**TOOELE CITY
WATER RECLAMATION FACILITY
TOOELE WRF 2026 UPGRADES PROJECT**

**ADDENDUM NO. 2
August 13, 2026**

03 - CIVIL UTILITY PLAN AREA A

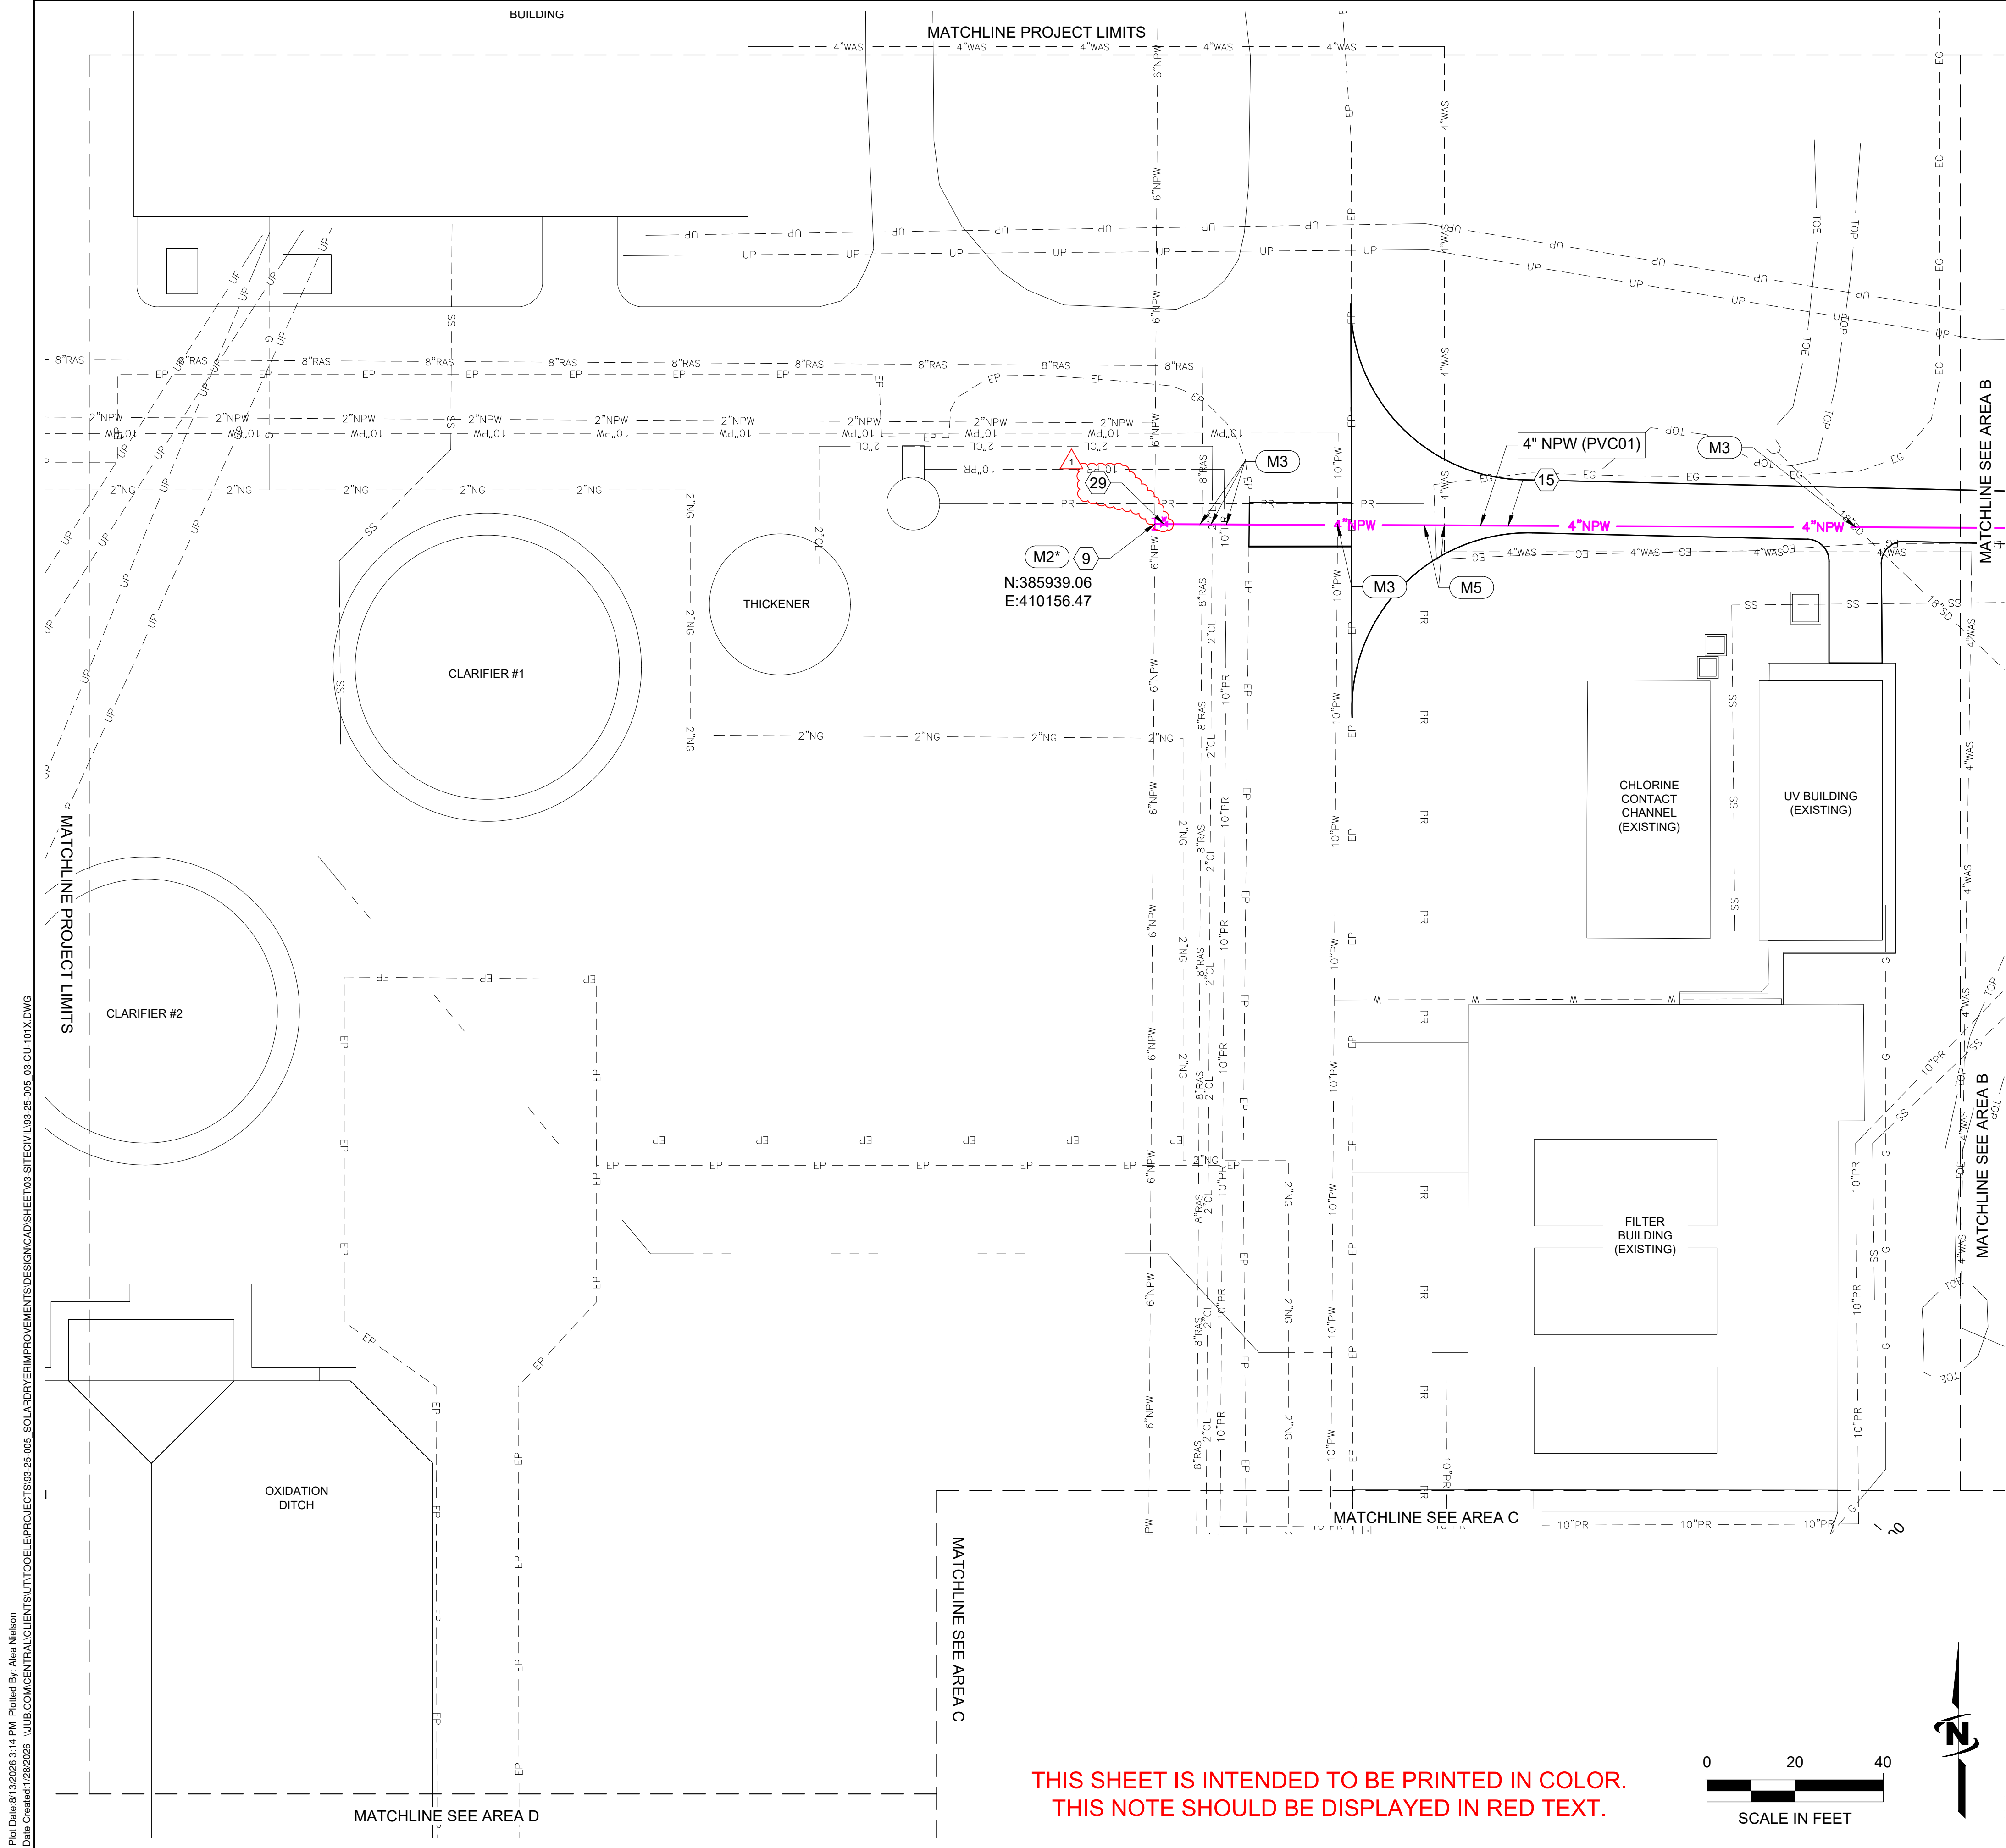
- ii. A 4" gate valve will be added to the 6"x4" NPW tee on sheet 03-CU-101 to isolate the 4" NPW line. The 4" gate valve will be added to sheet 03-CU-101 and included with Addendum #2.

- ii. “SIKA CJ-0725-3K Hydrotite” for the hydrophilic waterstop type with 2” min concrete cover.
 - c. Sheet 03-CU-101 (see attached)
 - i. New gate valve added.
- 4. Changes to the Technical Specifications:**
- a. Specification 43 30 62 (see attached)
 - i. Section 2.1A: Golden Harvest listed as an approved equal.
